TVA-WBN-TS-03-11

**WATTS BAR NUCLEAR PLANT (WBN) - UNIT 1 - PROPOSED EXIGENT
LICENSE AMENDMENT REQUEST CHANGE NO. WBN-TS-03-11 - EMERGENCY
CORE COOLING SYSTEM (ECCS) - VENTING HOT LEG INJECTION LINES**

PROPOSED LICENSE AMENDMENT REQUEST WBN-TS-03-11

DESCRIPTION AND EVALUATION OF THE PROPOSED CHANGE

FIGURE
 ECCS HOT LEG INJECTION &
 DCP COLD LEG INJECTION VENTING

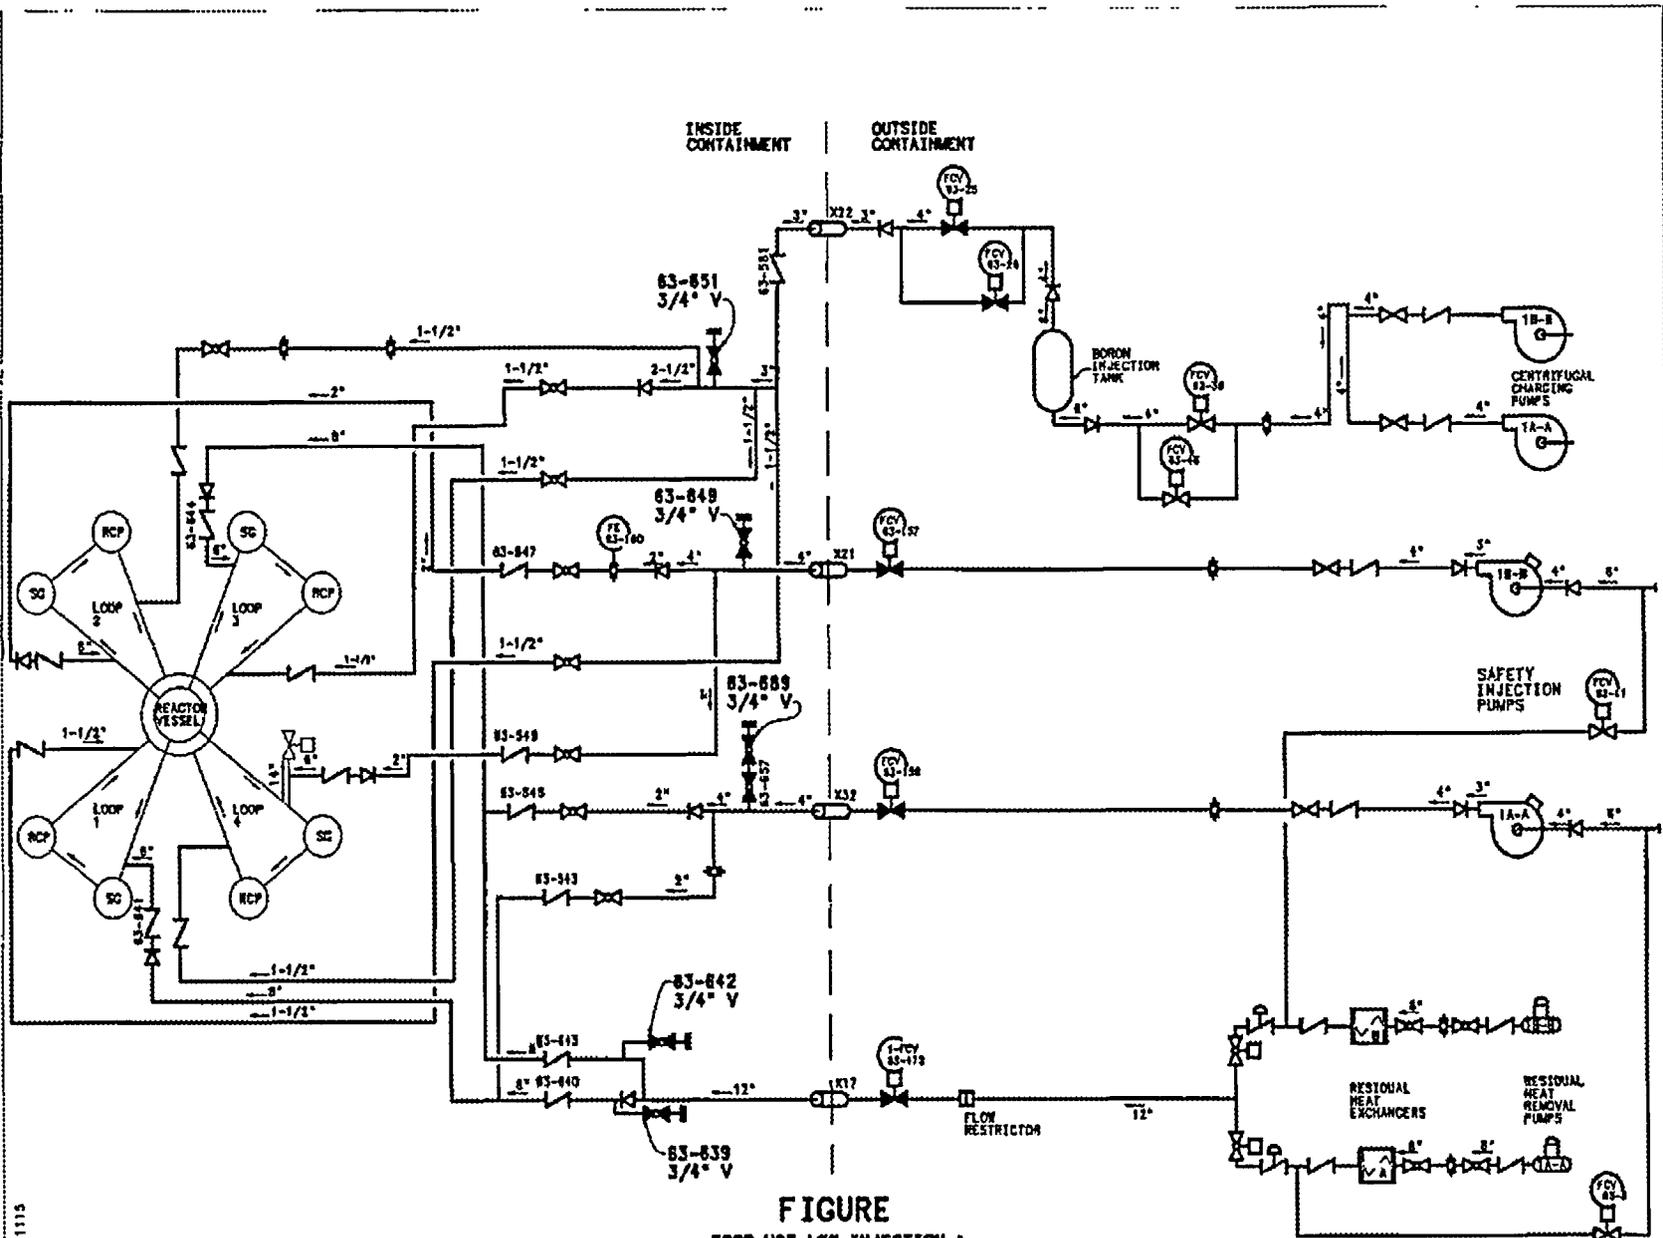
the remainder of the cycle. The locations of these high point vents are in the top of Fan Room Number 1 in lower containment.

The Updated Final Safety Analysis Report (UFSAR) describes the ECCS system in detail in Section 6.3. UFSAR Figure 6.3-1, Sheet 1 provides the flow diagram for the ECCS. (See attached simplified sketch).

TVA has reviewed the industrial safety impacts of performing ECCS venting monthly during plant operation. For one of the two valve locations inside Fan Room 1 near the ceiling, the employees would be required to transverse over the main steam line near the top of Fan Room 1. The surface temperature of the insulated steam line is approximately 144 degrees F. Personnel could be exposed to burns from this hot piping. Other system piping in the area was verified to be above 120 degrees F. TVA workers would need to reach around the other piping to access the valve operator and would be exposed to potential burn hazards.
